## MEMORANDUM

**Re:** **BPS Development Company, LLC**  
**Preliminary and Final Major Site Plan and Bulk Variances**  
Hartwick Drive & Village Drive  
Block 28003, Lot 211  
ARH Age Restricted Housing Zone

**Date:** January 31, 2023

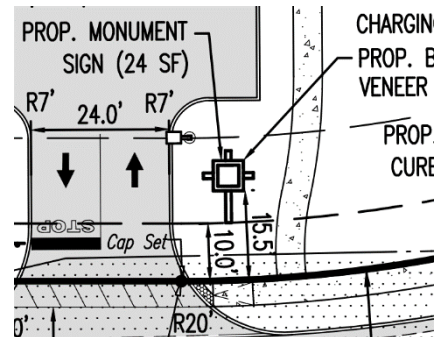
- 6.9. **Bollard Lighting: *More information is required.*** Bollard lighting is not indicated on the lighting plan, however, a detail for bollard lighting is included on sheet 16 of

the plan. The lighting plan should be updated to include the bollard lights and the impact of the lights should be included in the calculation summary.
